Access Compliance Report

Public Rights-of-Way

Intersection ID: 24436	Main Street: CARMEL_RD	Cross Street: WINGEDFOOT_RD	Location: SW
ADA ID: 91293222C725	Ramp Type: PerpDiag	Initial Pass/Fail: Fail	Overall Compliance: No
		Severity Score: 22.5

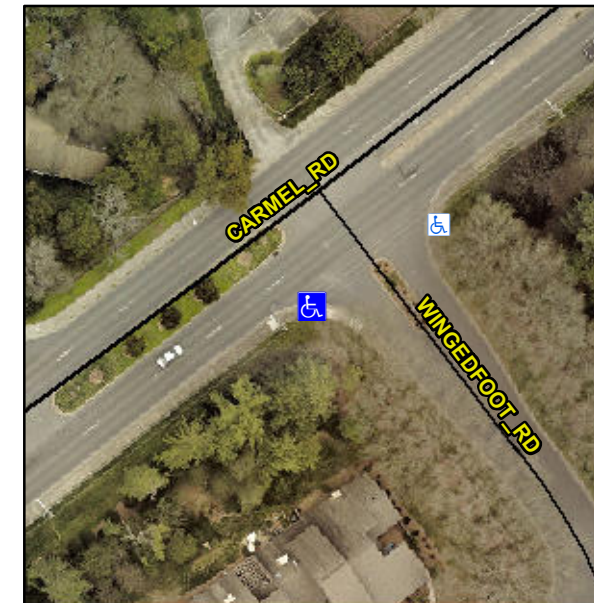
Not Found, R304.5.1, R304.2.2, R304.5.3

Compliance	Description	Data	Compliance	Description	Data
N/A	Ramp Length (in)	60.0	No	Ramp Slope (%)	10.8
No	Ramp Width (in)	39.0	No	Ramp XSlope (%)	3.5
N/A	Flare Type LT	N/A	N/A	Flare Type RT	N/A
N/A	Flare Slope LT (%)	N/A	N/A	Flare Slope RT (%)	N/A
N/A	Flare Traversable LT?	N/A	N/A	Flare Traversable RT?	N/A
N/A	Landing Length (in)	N/A	N/A	DWS Provided?	N/A
N/A	Landing Width (in)	N/A	N/A	DWS Contrast?	N/A
N/A	Landing Slope (%)	N/A	N/A	DWS Length (in)	N/A
N/A	Landing X Slope (%)	N/A	N/A	DWS Full Width?	N/A
N/A	Landing Curb? (Y/N)	N/A	N/A	DWS Offset (in)	N/A
N/A	Shared Landing?	N/A			
N/A	Gutter Ponding?	N/A	N/A	Gutter Slope (%)	N/A
N/A	Gutter Lip Ht (in)	N/A	N/A	Gutter X Slope (%)	N/A
N/A	Painted X Walk1?	No	N/A	Painted X Walk2?	No
	X Walk 1 Direction	To NE		X Walk 2 Direction	To N
N/A	X Walk 1 Width (in)	N/A	N/A	X Walk 2 Width (in)	N/A
	X Walk 1 Slope (%)	0.0		X Walk 2 Slope (%)	3.3
	X Walk 1 X Slope (%)	3.0		X Walk 2 X Slope (%)	0.3

Remove & Replace Curb Ramp With Two New Directional Ramps or Equivalent.
